Illinois Tollway Base Sheet Revisions

Section M		Base Sheet Drawings	
Drawing	Modification Summary	Effective: 2020-03-01	
Pole Assembly (ITS)-Series 1000			
M-ITS-1000	Elevation Views Pole Mounted ITS Element Assembly		
	Use 1 1/2" stainless conduits for power and fiber to ITS Enclosure instead of 2". Corrected the MVDS mounting height on elevation details Use 1 1/2" stainless conduit for ITS Disconnect switch		
M-ITS-1001	General Notes Pole Mounted ITS Assembly		
	Note added on placement of battery enclosure		
M-ITS-1002	ITS Standard Foundation		
	Note added to use 12 ft helix foundation for slopes over 1:6		
M-ITS-1003	ITS Concrete Service Pad		
	Shows option for back-to-back mounted ITS enclosures.		
M-ITS-1004	Cabinet Wiring Diagram - ITS Pole Mounted Enclosure (Solar Powered MVDS) (2 sheets)

M-ITS-1302

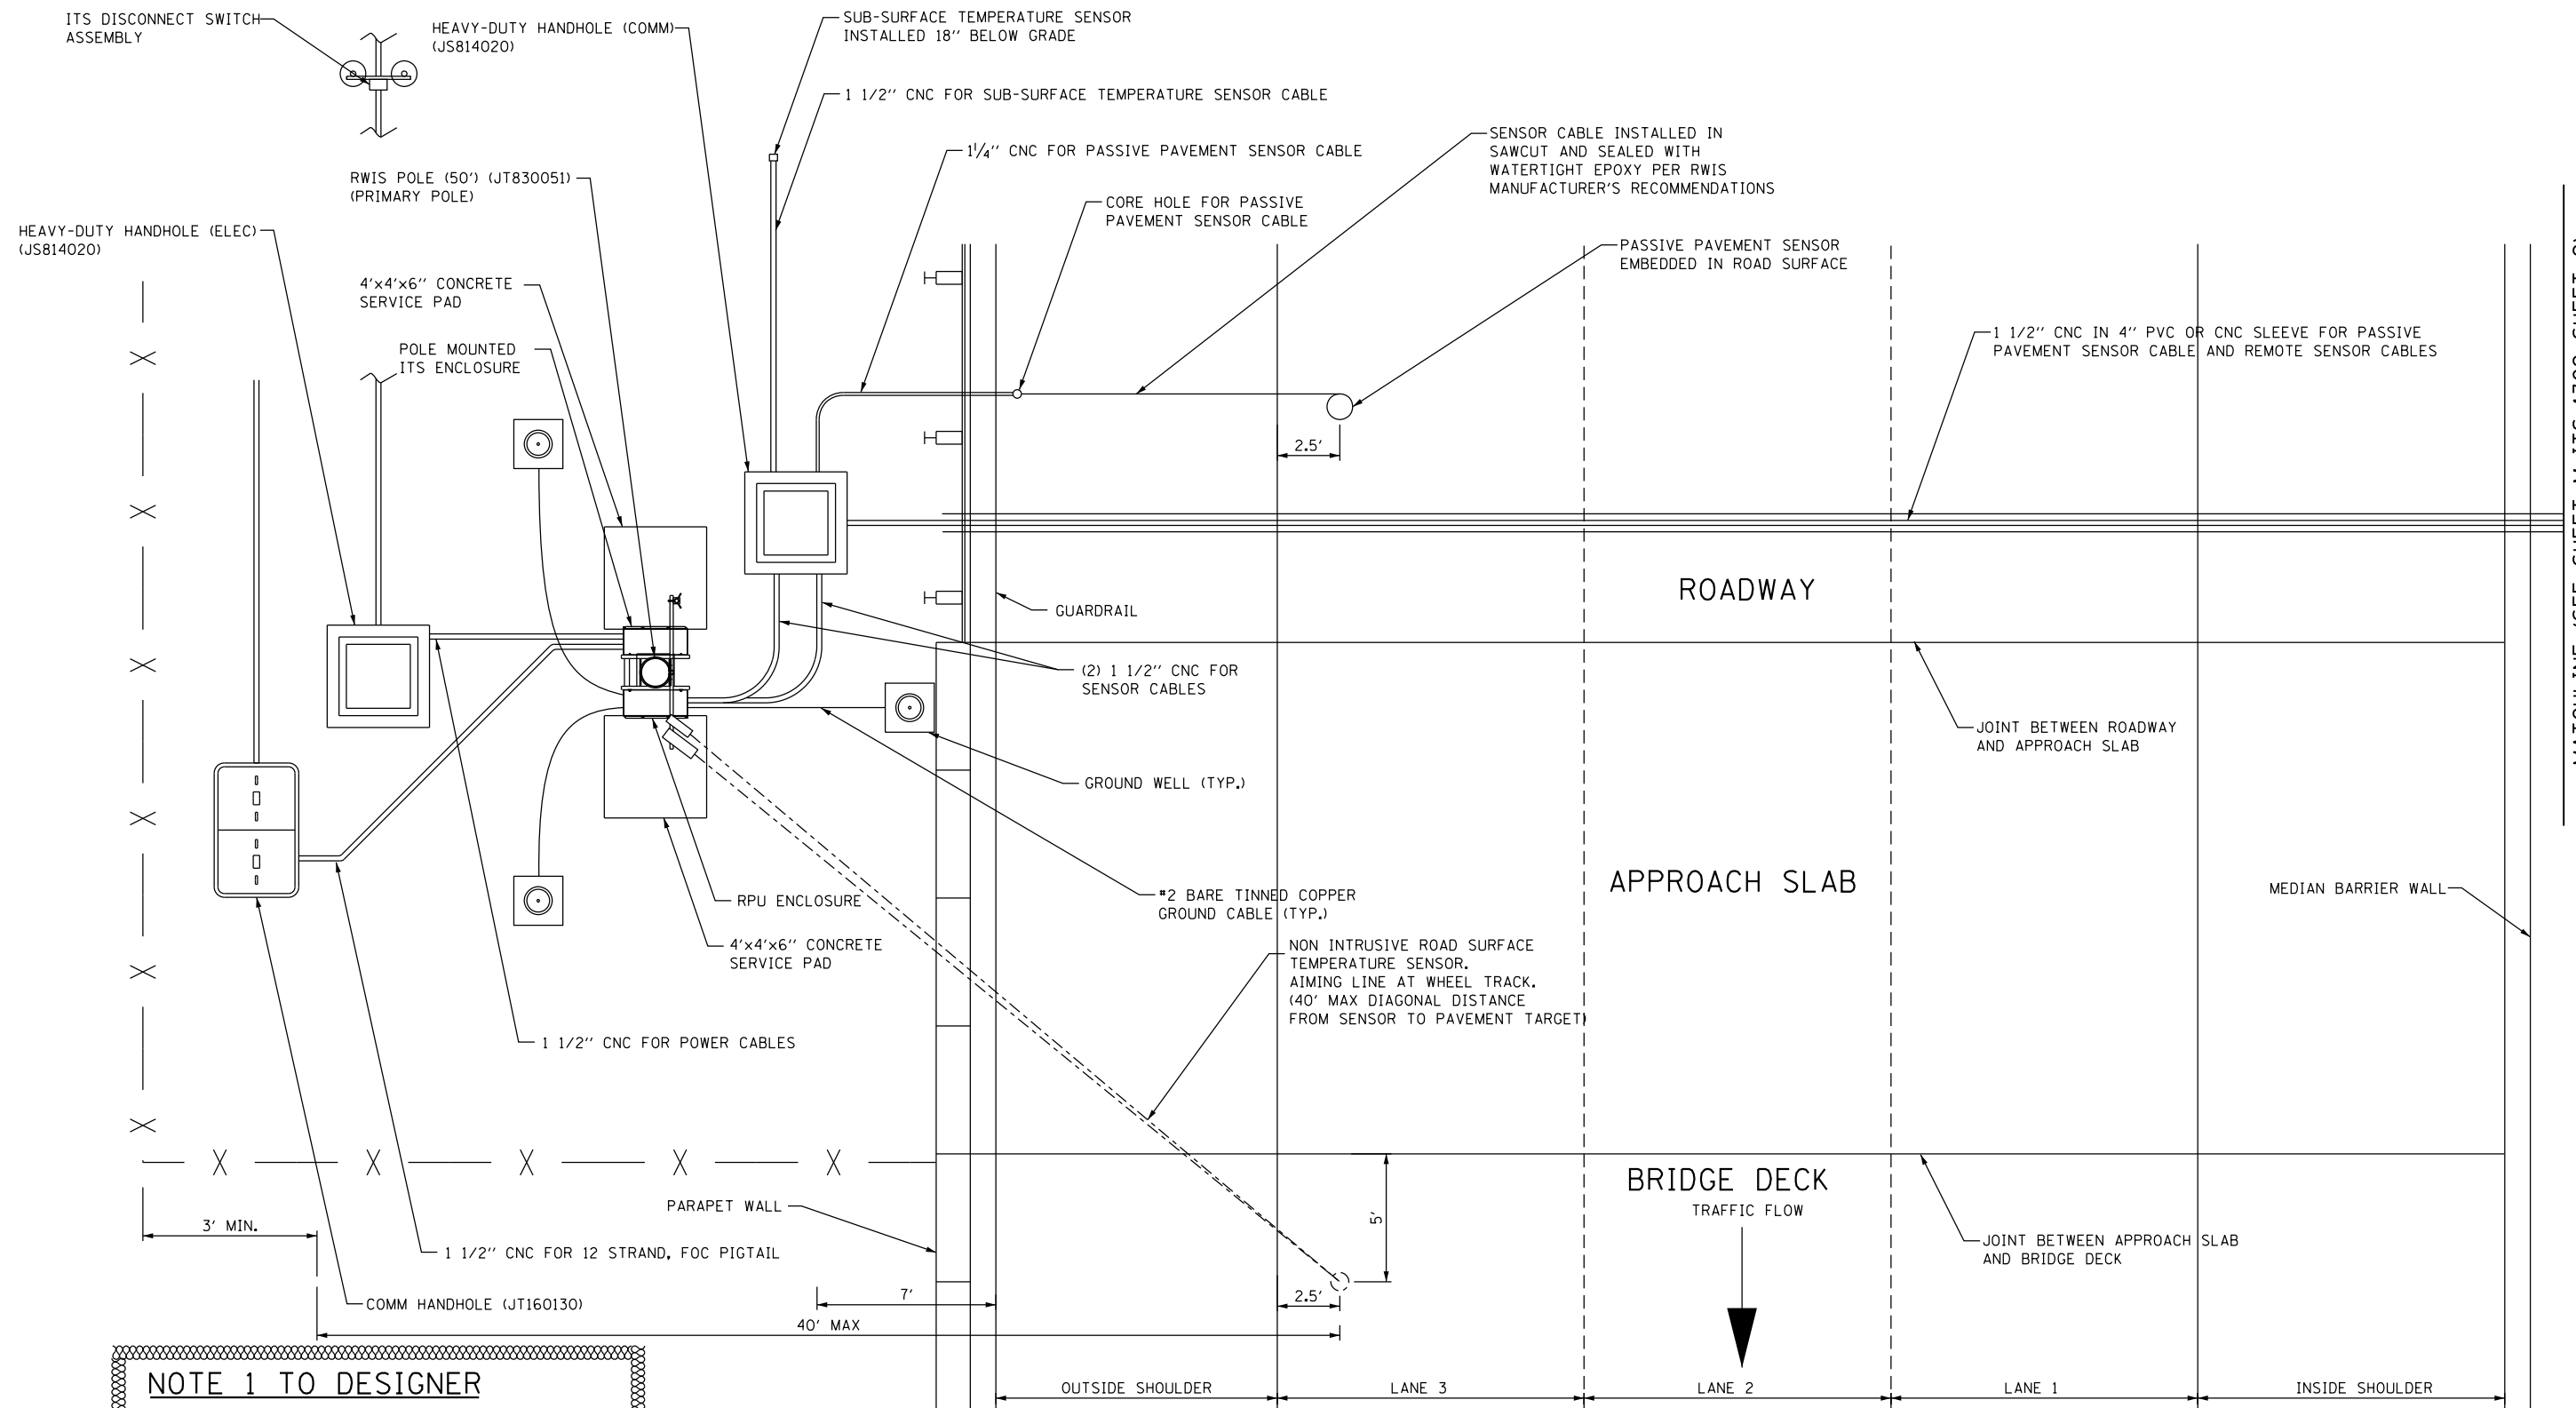
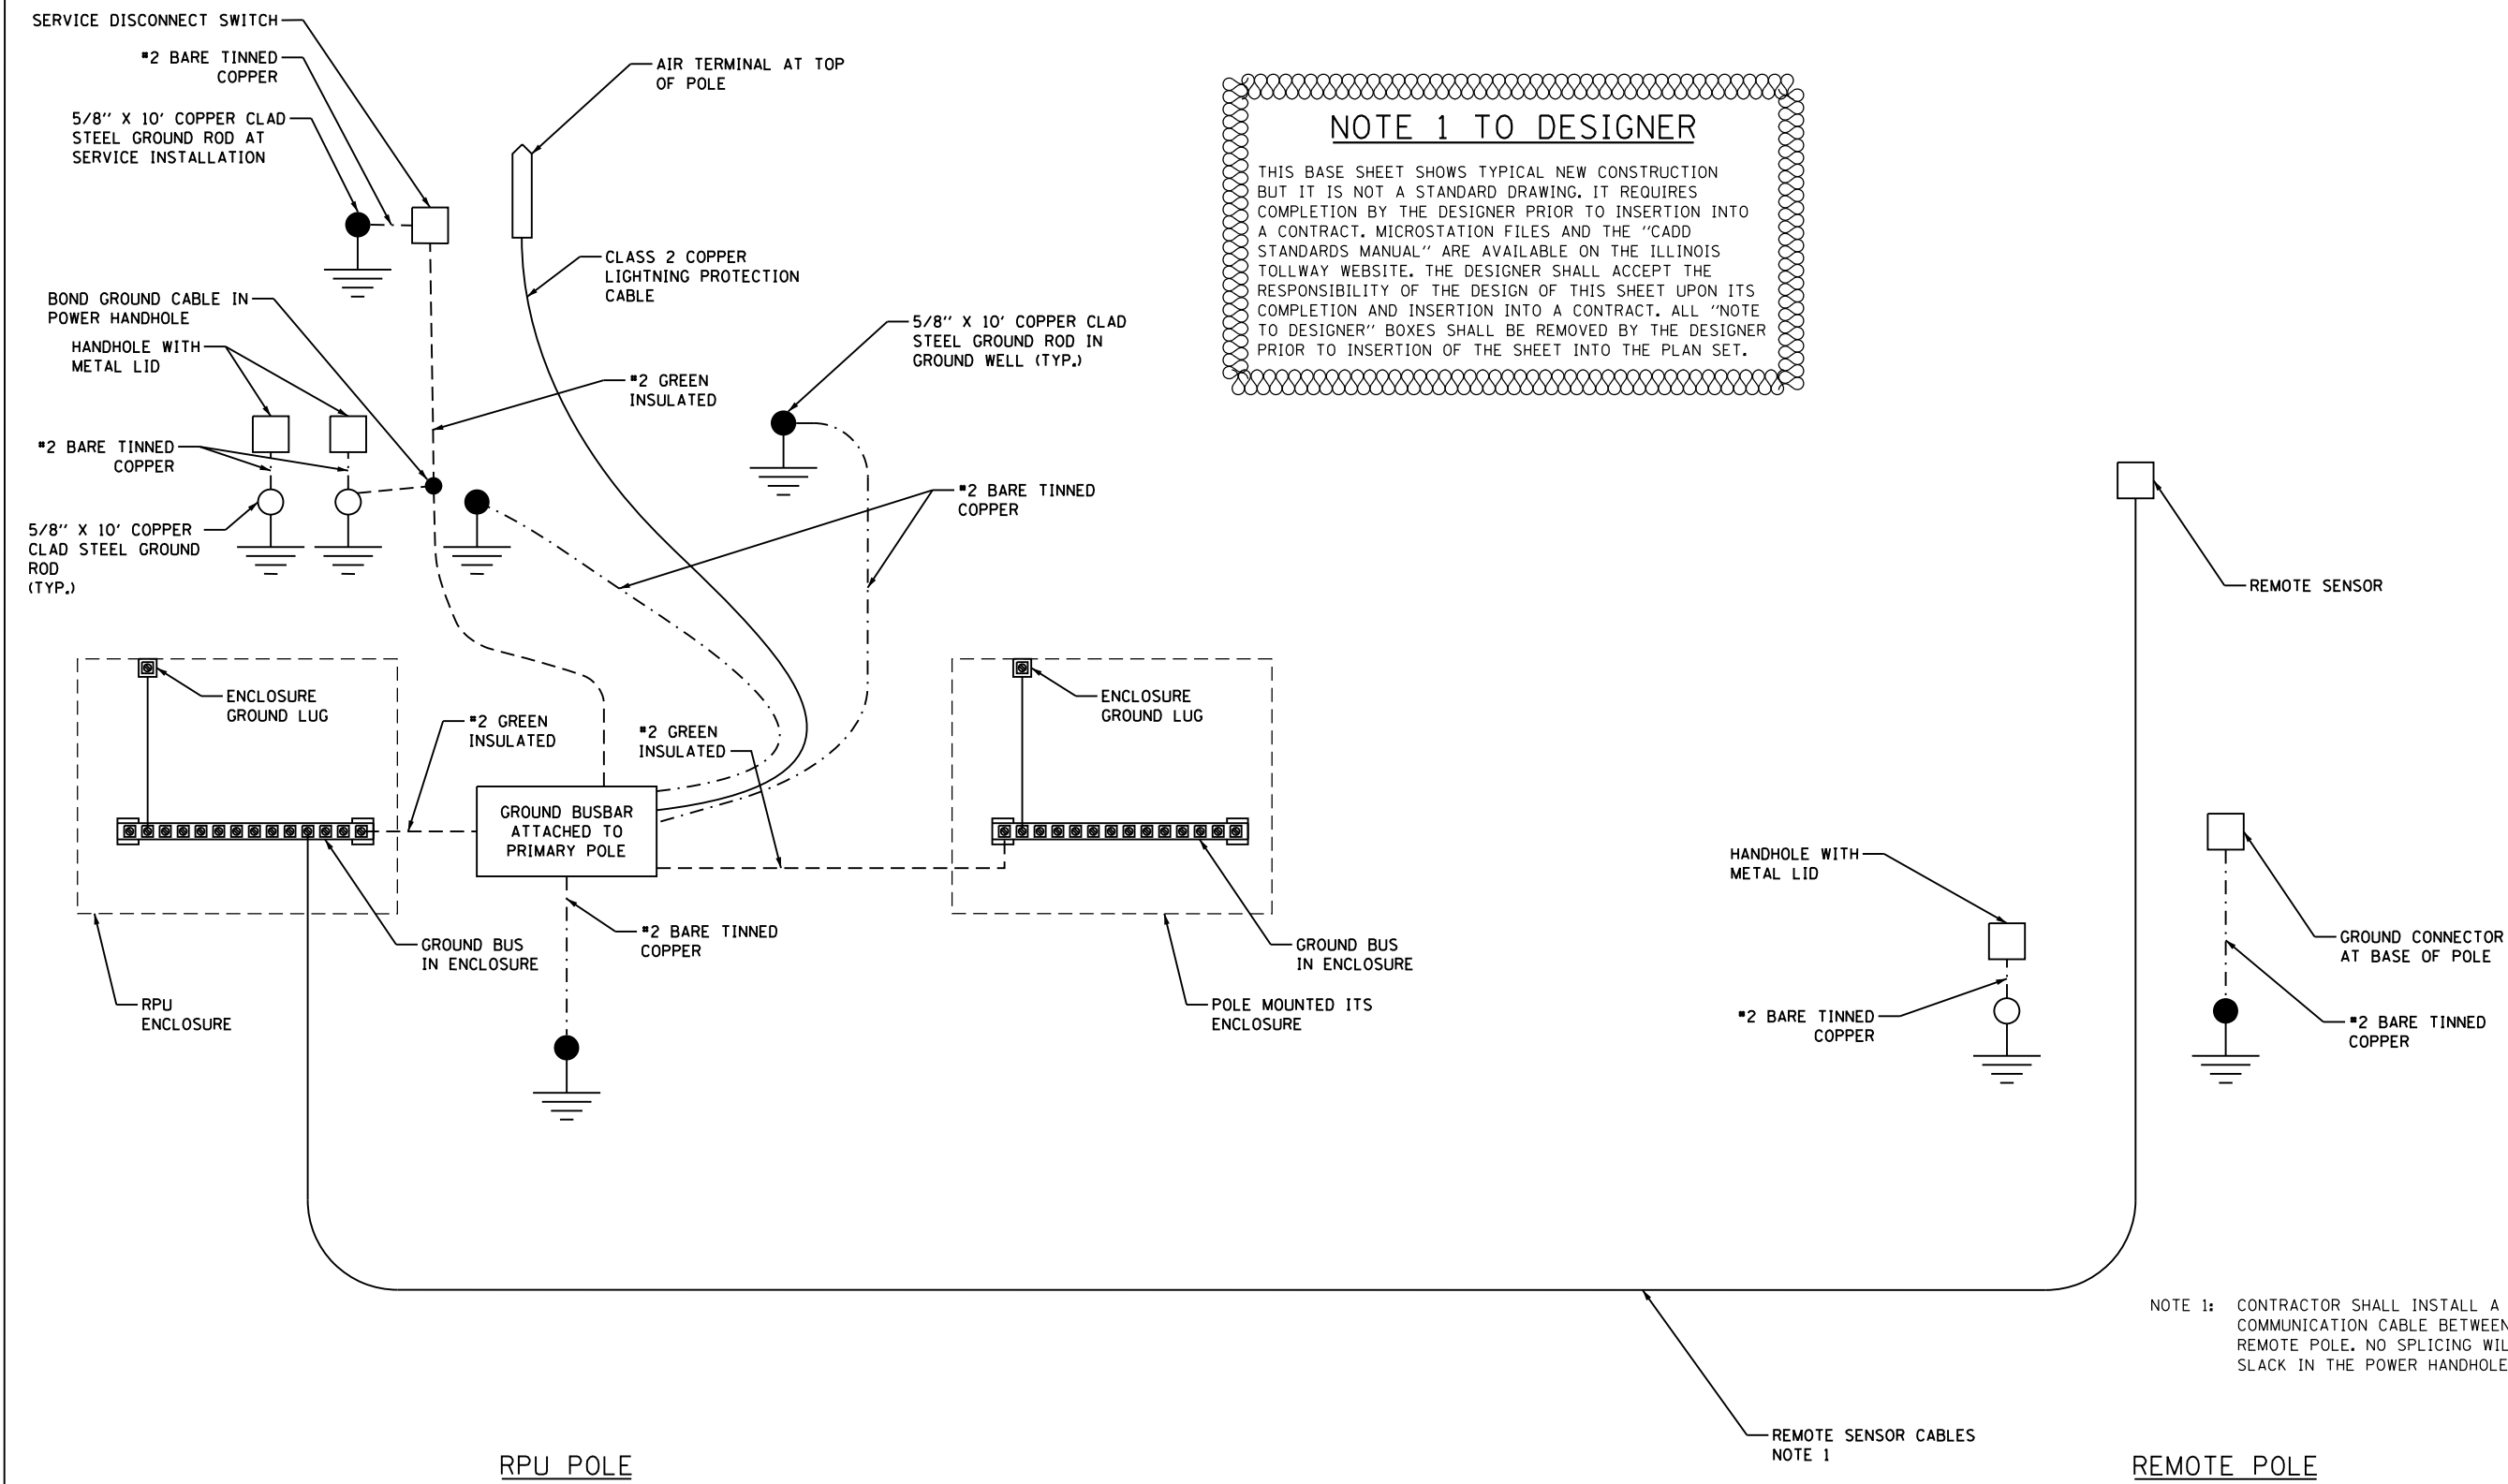
M-ITS-1301	RWIS Cabinet Wiring Diagram		
	Removed Cisco switch and gator patch from RPU enclosure		
M-ITS-1302	Typical RWIS Site Installation Plan		
	Proposed location of temperature sensors are site specific, final position to be determined by the Engineer in consultation with manufacturer. Correct sensor beam position to be in the wheel track for primary and secondary pole. Power cable from primary pole to secondary pole not to be spliced		
M-ITS-1303	RWIS Grounding Schematic		
	Corrections and additional detail to grounding diagram
